DEPARTMENT OF FISCAL SERVICES

To: PROSPECTIVE PROPOSERS AND ALL OTHERS CONCERNED
From: Amy Rossi, CPPB, Sr. Contracts Analyst
Subject: BD-2110-04/AJR – Mezzanine & Shelving
Due Date: December 28, 2004 @ 2:00 PM

ADDENDUM #3

Ground Floor

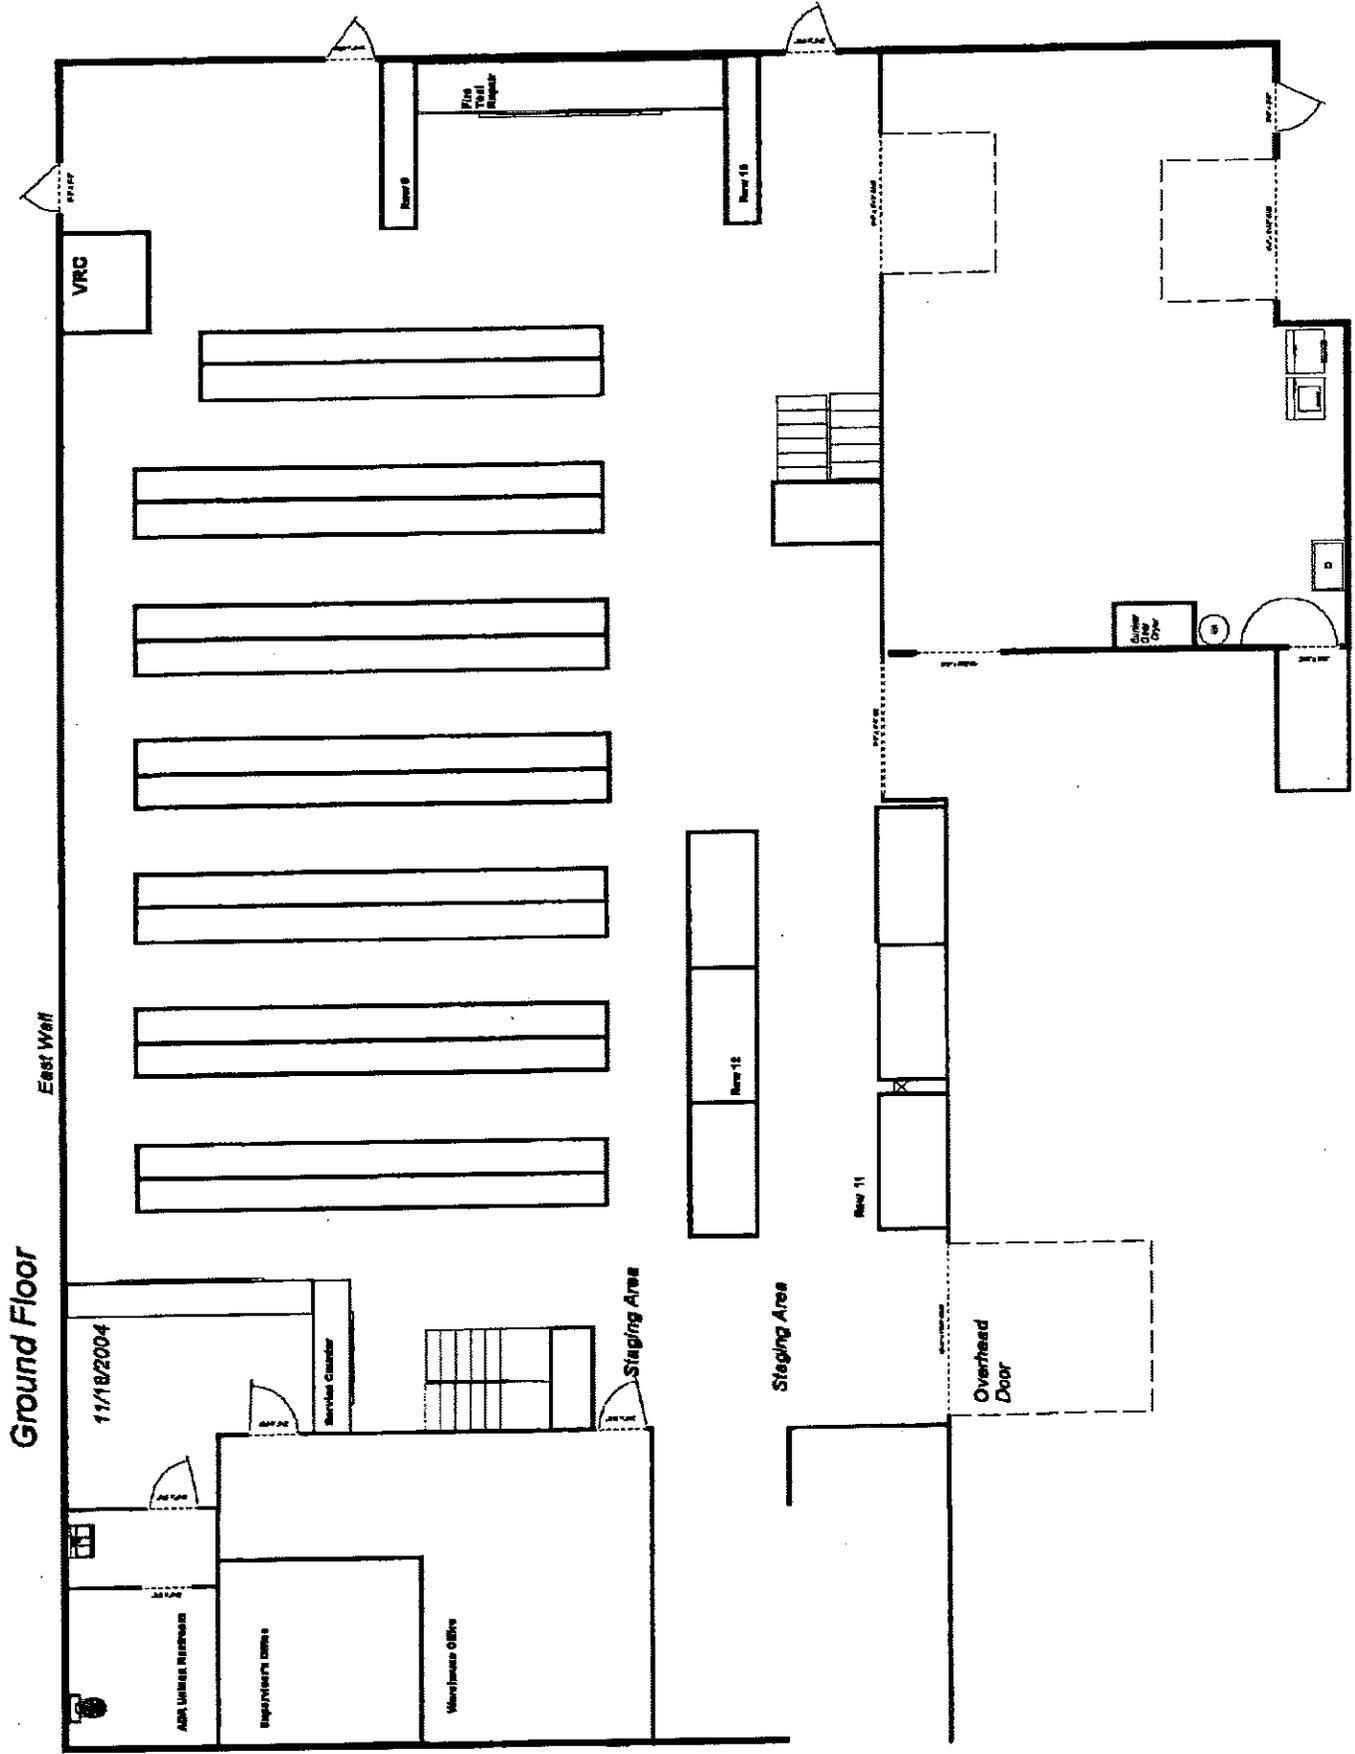
The specifications for the shelving indicates that row 8 is a 12' wide row, but I do not see row 8 on the drawing supplied at the pre bid meeting. The bid packet also indicates that rows 1-7 are all the same length but the drawing shows row 7 slightly shorter than the rest. Please advise on how to proceed with the layout for accurate pricing.

Row 8 was removed from drawings and should be removed from specifications. Row 7 is shorter than other rows because of working room around Option 1 (VRC). If Option 1 is not accepted, row 7 will be same length as rows 1 to 6.
